**GULF STATES UTILITIES COMPANY**

February 6, 1985  
RBG- 20,086  
File No. G9.5, G9.23,  
G9.8.6.2

River Bend Station - Unit 1  
Docket No. 50-458

Enclosed are revisions to the River Bend Station Final Safety Analysis Report for your information. Attachment 2 supplements and/or revises my letter of November 29, 1984 (RBG-19,576) on this subject. These revisions support previous discussions with your staff and will be appropriately included in a future FSAR amendment.

FSAR Figure 7.3-23  
Sheets 29 thru 38

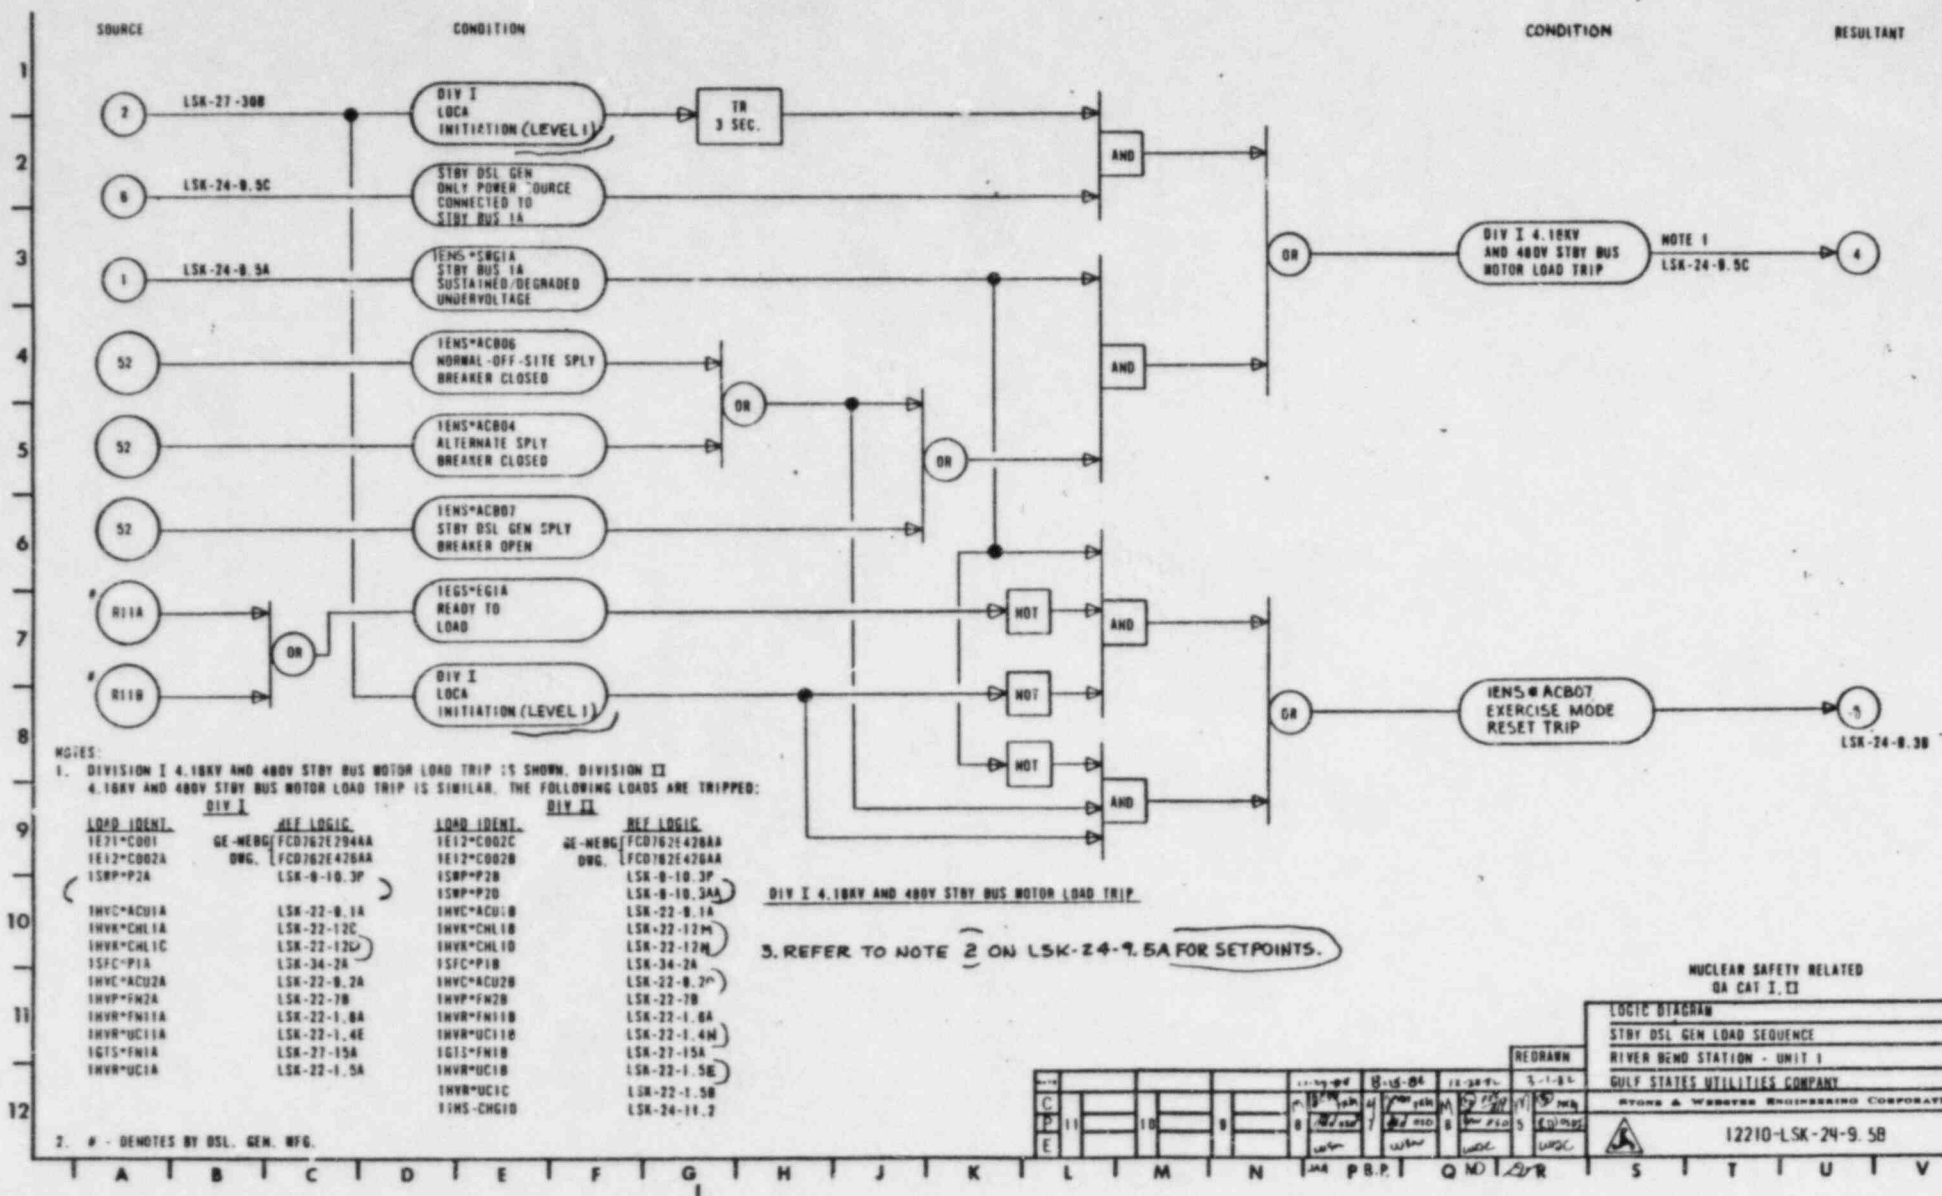
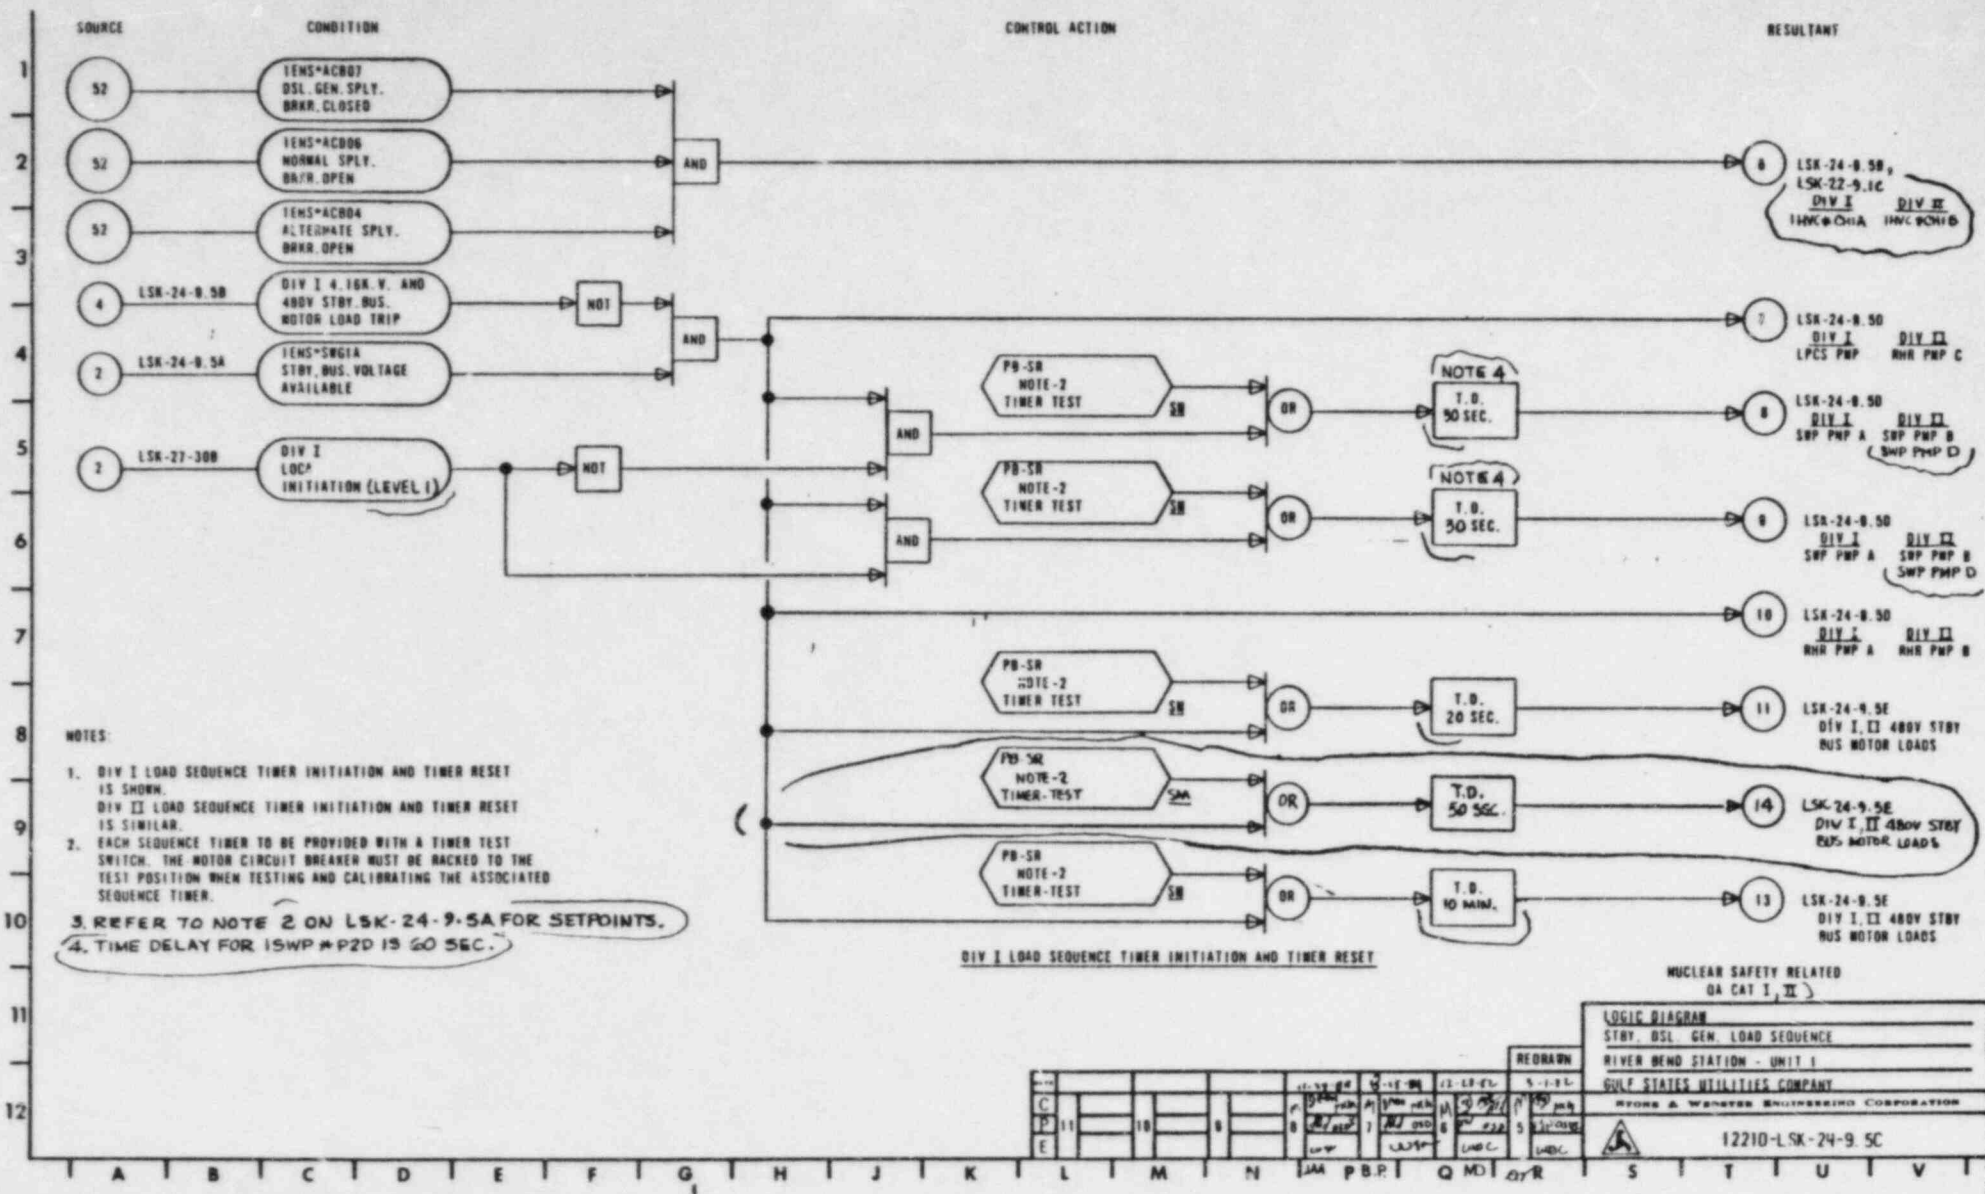
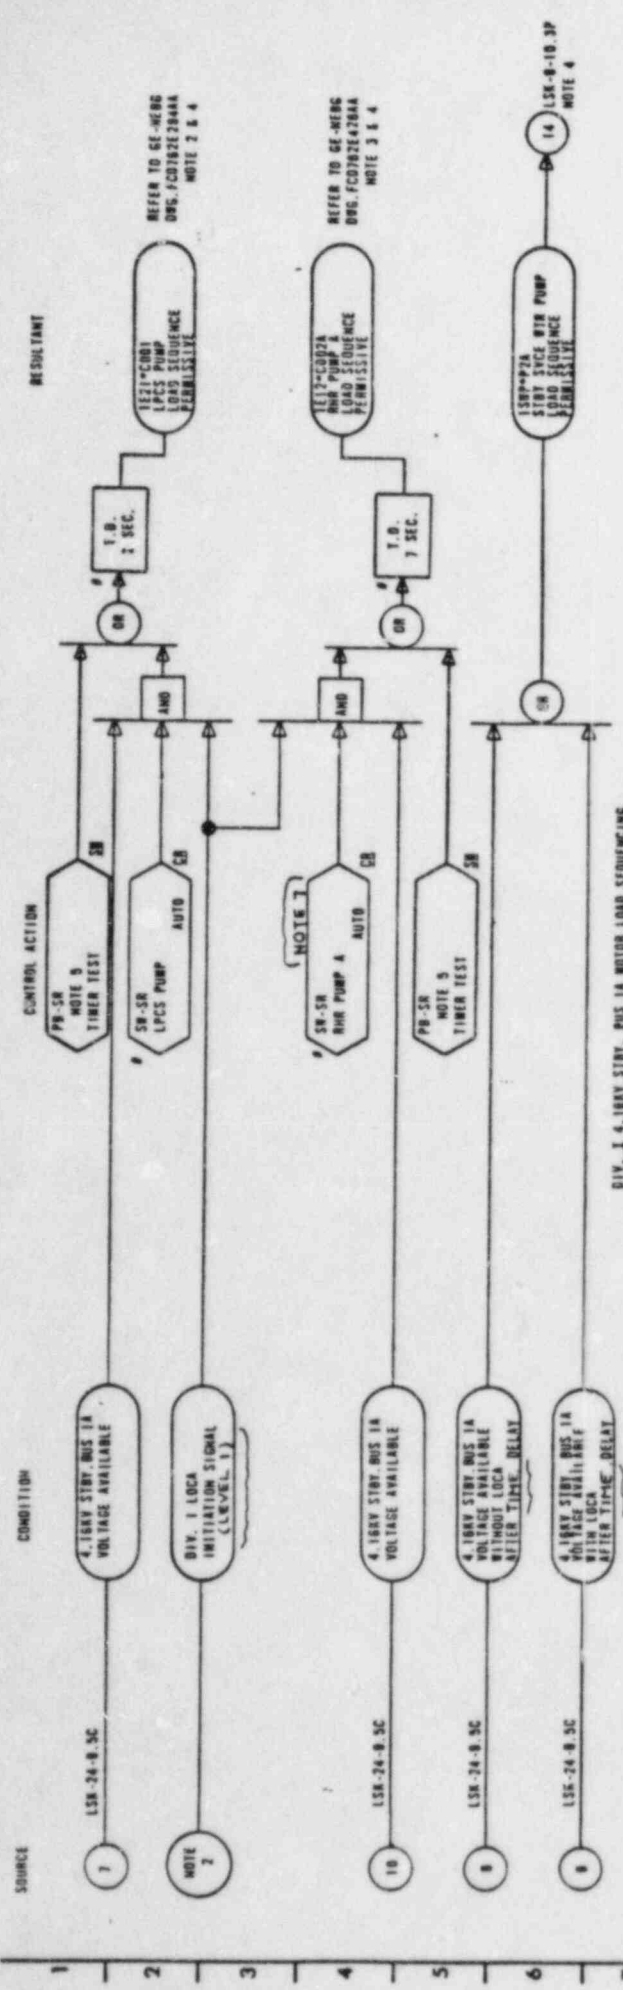
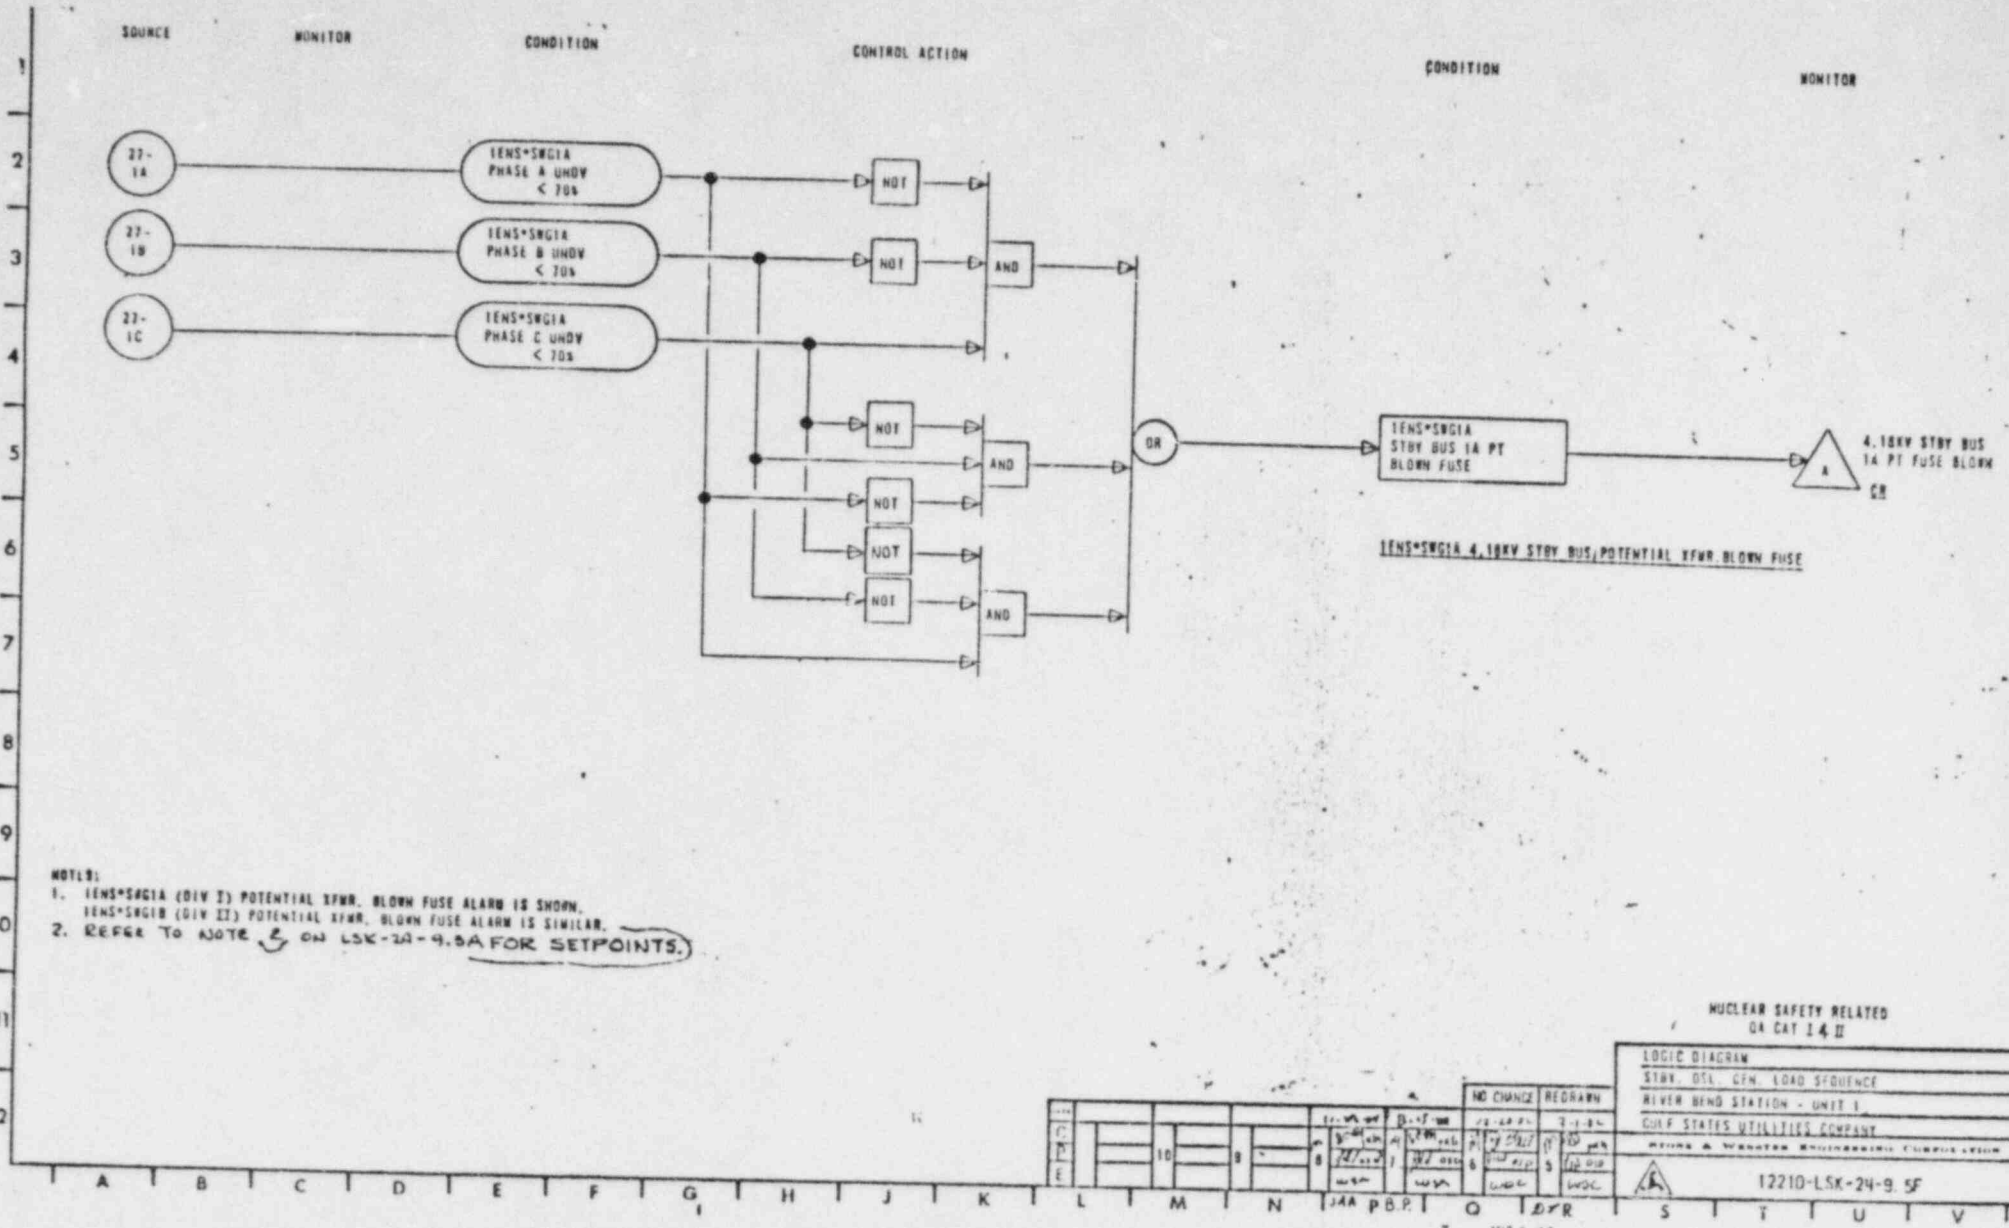
will be updated to reflect the attached LSK's.

FSAR Figure 7.6-7 Sheet 1

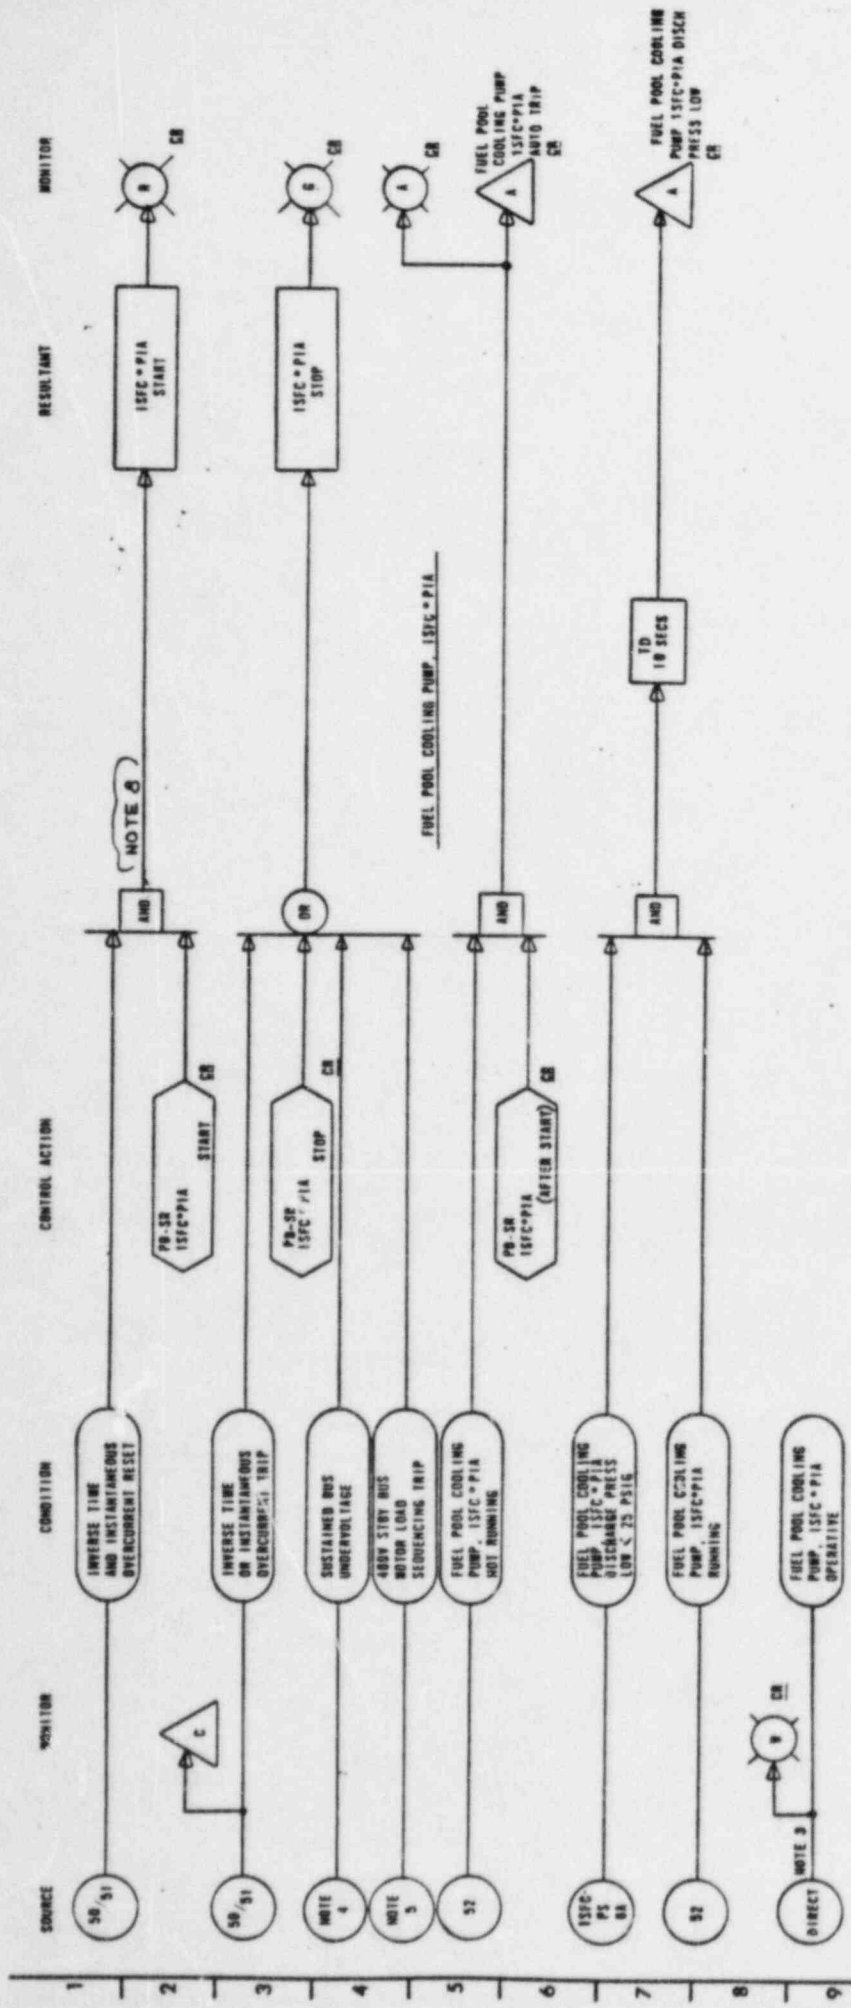
will be updated to reflect the attached LSK's.
